TRANSMITTAL OF RESOLVED REVIEW COMMENT RECORDS (RCRS) FOR THE RESTART OF DC-24, DC-25, DC-32 AND DC-33 DRILLING OPERATIONS UNDER THE EXPEDITED SPECIAL CASE

BWIP REVIEW COMMENT RECORD (RCR)

FIGURE 2

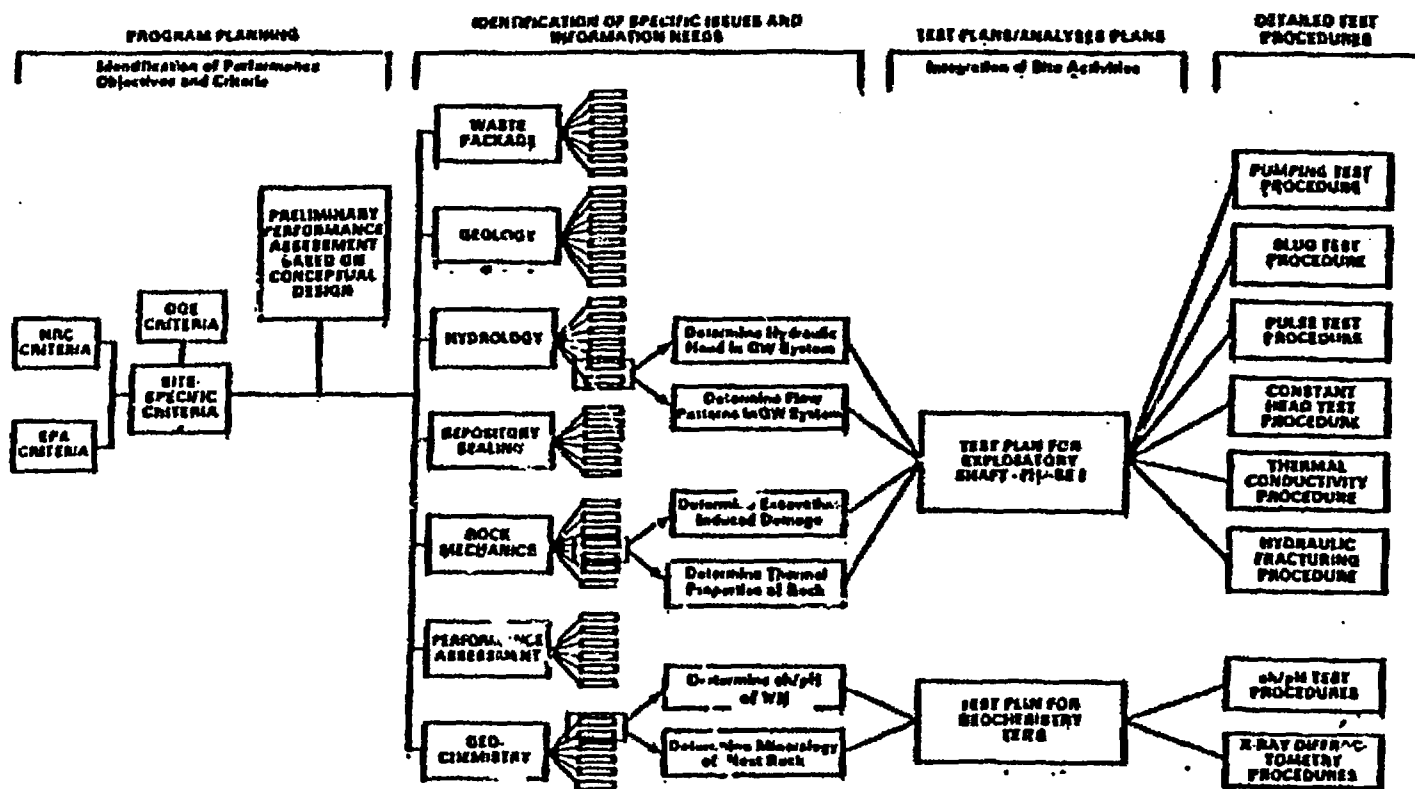
"The plans outlining the conduct of a data gathering program are of varying levels of detail ranging from identification of general performance objectives and criteria to detailing specific technical procedures (Figure 2, see attached)."
